AMENDMENT NO. 1 TO SOLICITATION

SOLICITATION NUMBER: USC-RFP-3543-CJ

DESCRIPTION: Furnish, Deliver and Install New HD Video Scoreboard for Carolina Softball Stadium at Beckham Field

DATE: October 14, 2019

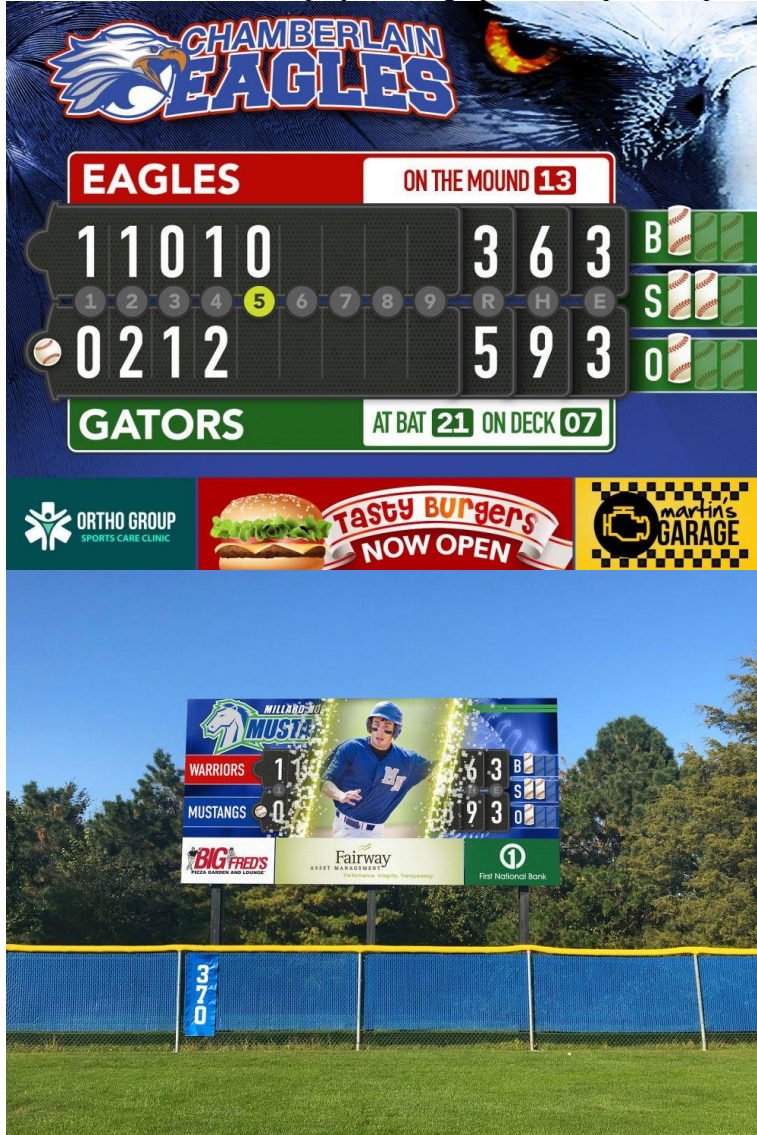
QUESTION 1: One important question that I have is around the fixed digital requirement. We can include this along with the videoboard, but our software is integrated, so that no fixed digital is required. I am including an image of our Scoreboard, so that you can see what it looks like. This does not interfere with the video feed or display, making operations quite simple.

ANSWER: A static scoreboard is still required.
